ENGINEERING CHANGE NOTICE NO.

DWG TITLE: SKID DEFLECTOR ASSY

Date: 15.04.13	Job No.:	ADR Yes/No: N	ADR Date:	ECN #: 15- 555
Product No.: Apical 145-21, 350-61		Created By: KJ	Approved By: <i>[Signature]</i>	
Product Name: Cable Cutters		Checked By: <i>[Signature]</i>

Reason for Change:
Revised hole dimensions, added delta notes 7-10 (647.1700), Revised dimensions of holes (650.9200)

SHEET 1, ZONE B5 IS:

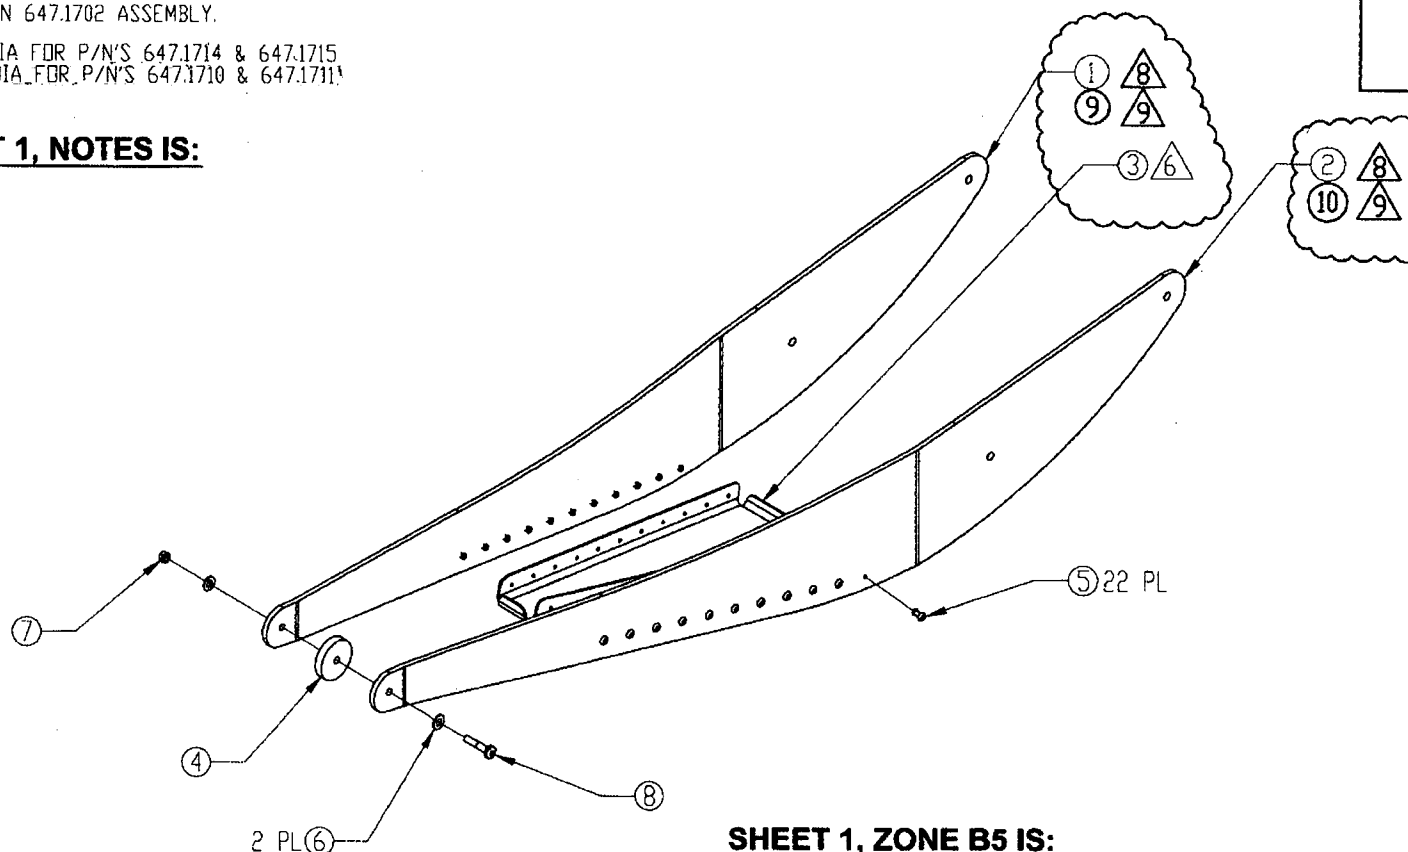
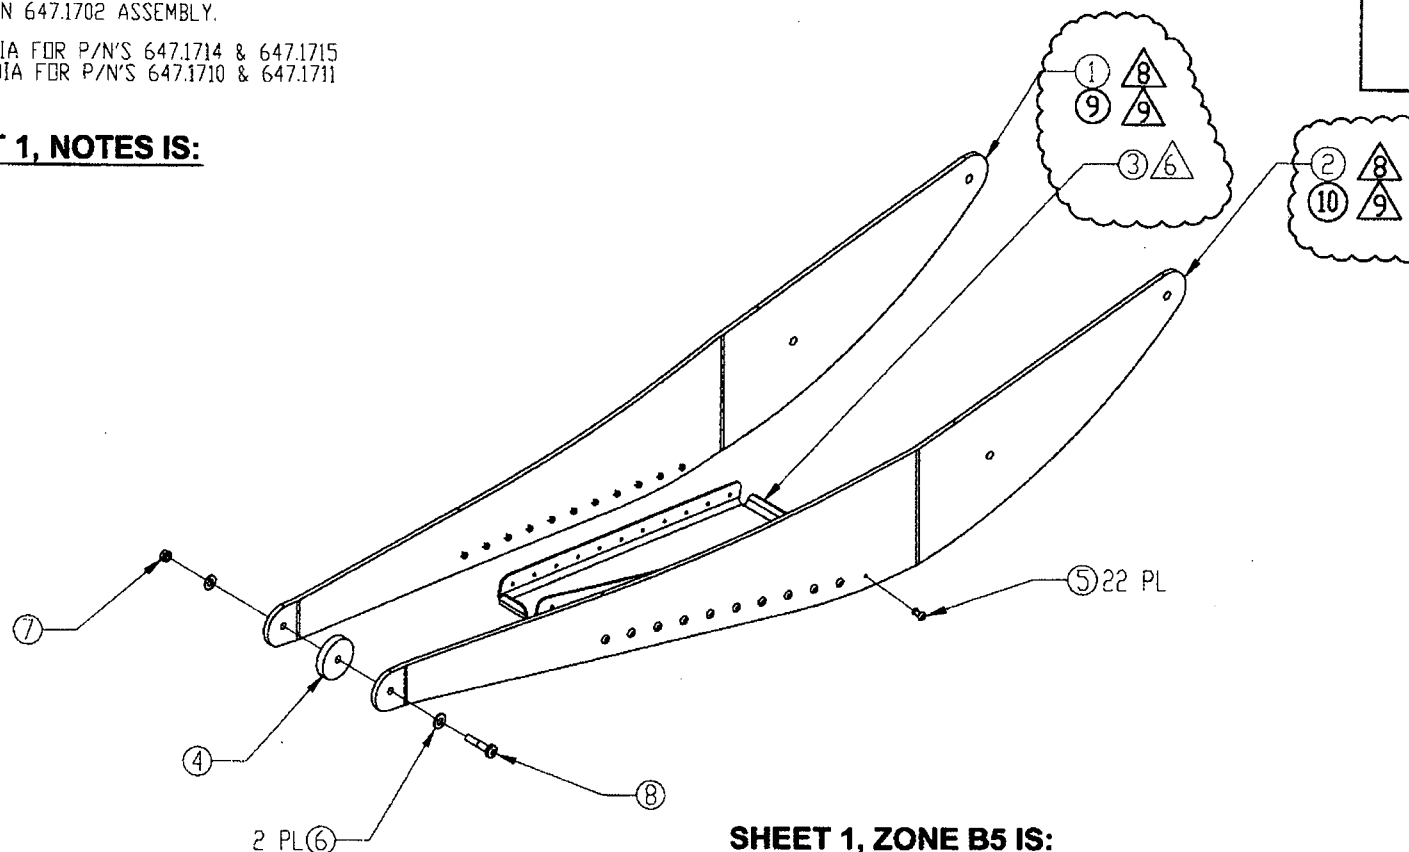
REASON: REVISED HOLE DIMENSION. ADDED DELTA NOTES 7-10.

7 WITH EXCEPTION OF HOLE DIMENSION, ALL DIMENSIONS SAME AS P/N 647.1710 AND P/N 647.1711. RESPECTIVELY.

10 323" DIA FOR P/N'S 647.1714 & 647.1715
257" DIA FOR P/N'S 647.1710 & 647.1711

△ 10 .323" DIA FOR P/N'S 647.1714 & 647.1715
.257" DIA FOR P/N'S 647.1710 & 647.1711

647.1714 SHOWN
647.1715 OPPOSITE

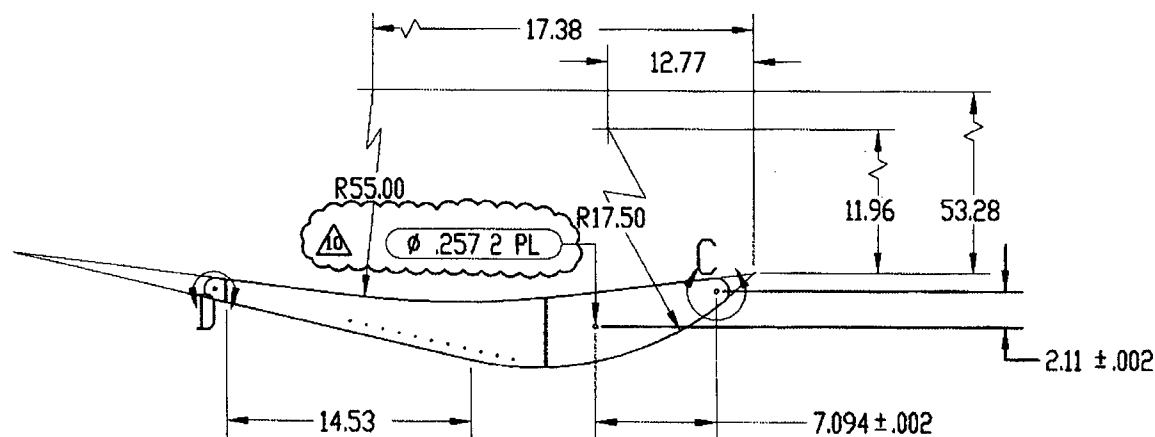
SHEET 3, ZONE C8 IS:

SHEET 3, ZONE D4 IS:

647.1711 SHOWN
647.1710 OPPOSITE

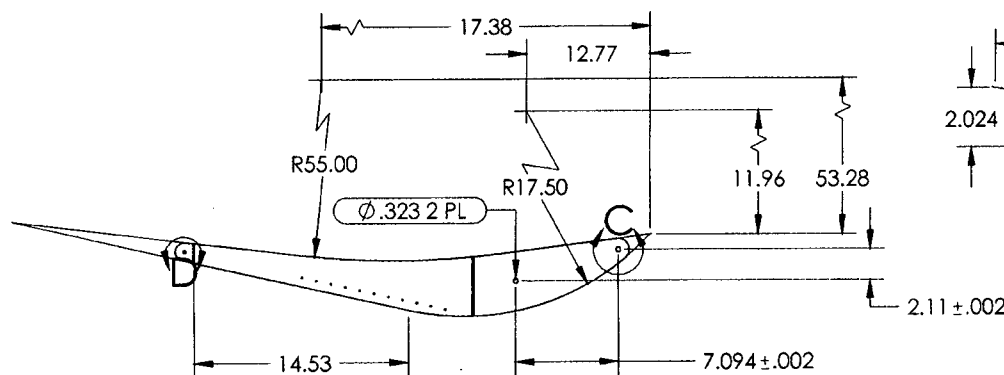
REDRILL HOLES TO NEW SIZE AT .257

AS PER ECN 15-555

TOUCH PAINT IN HOLES THAT WERE REDRILLED
